DRUMMOND COMPANY, INC.
P.O. BOX 1549 JASPER, AL 35502
205-387-0501 OFFICE

SURFACE MINE # 1
P-3869 / REVISION R-5
SEC. 2, 3 & 4 T. 14 S. - R. 8 W.
SEC. 33, 34 & 35 T. 13 S. - R. 8 W.
WALKER CO. ALABAMA

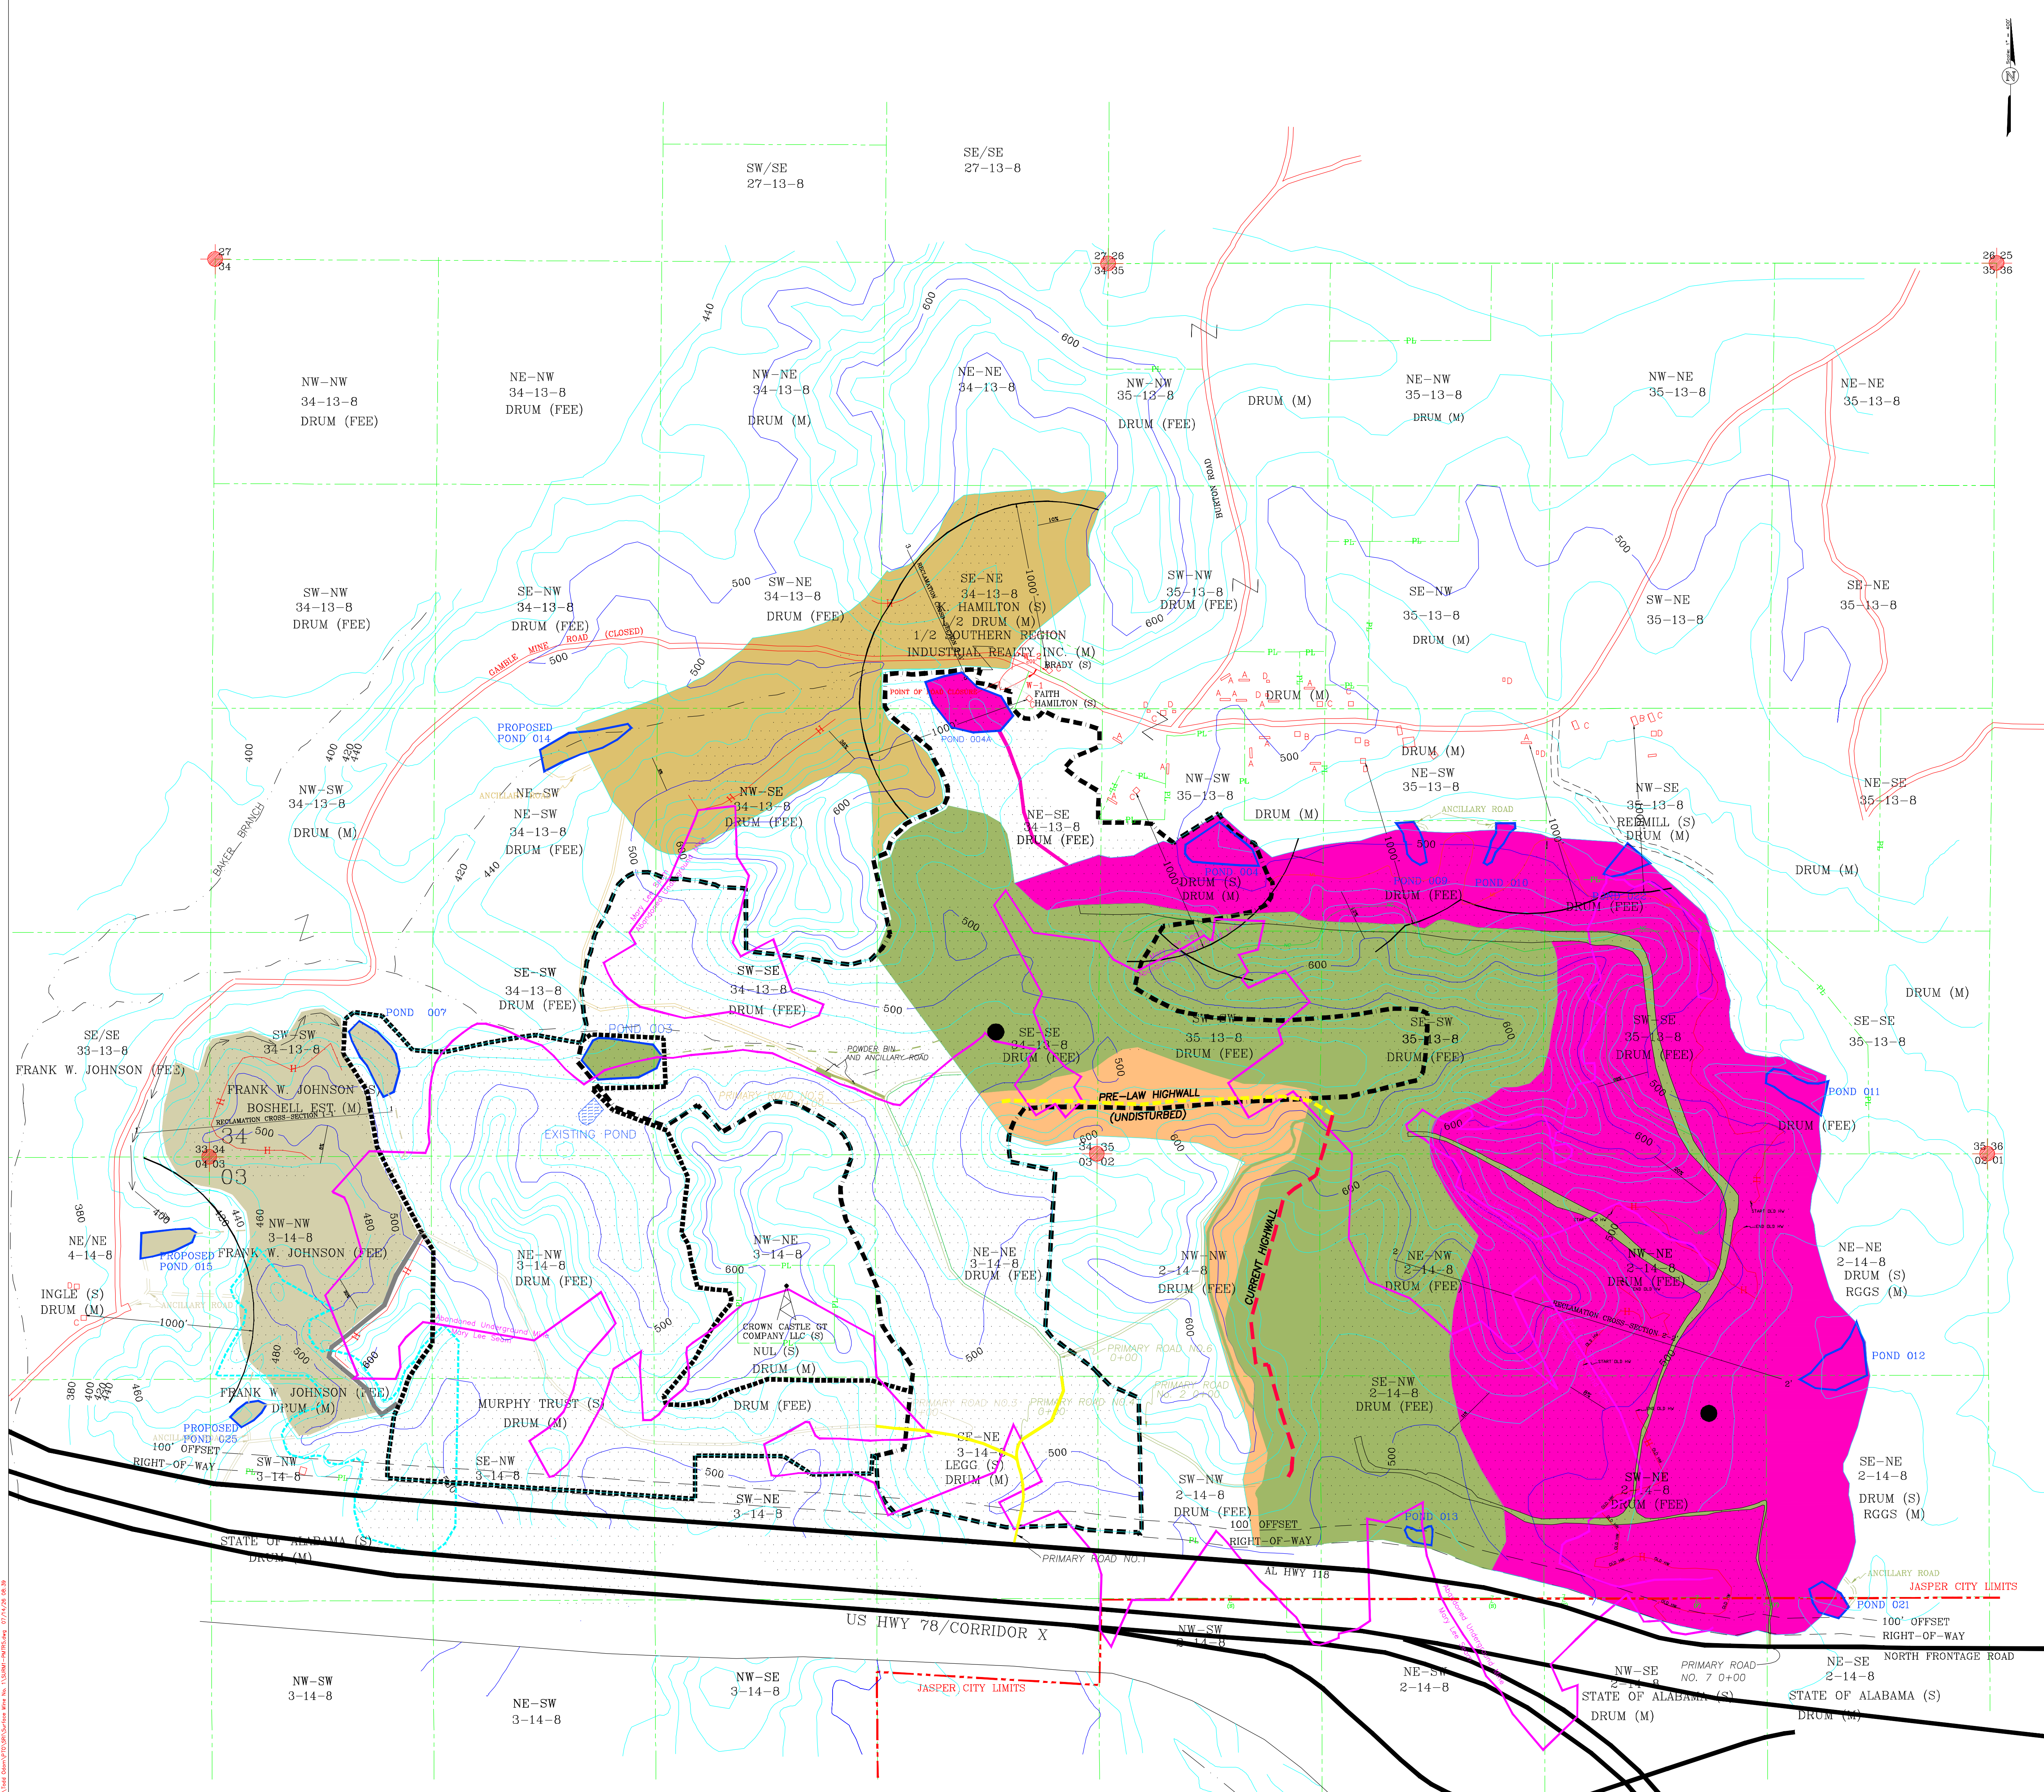
-Request an Addendum to the Reclamation Plan to Leave a Portion of the Existing Highwall Un-Reclaimed by Experimental Practice Through ASMC Regulation 880-X-8J-4.
	-Delete 24.0 Acres from Increment No. 1 as Undisturbed.
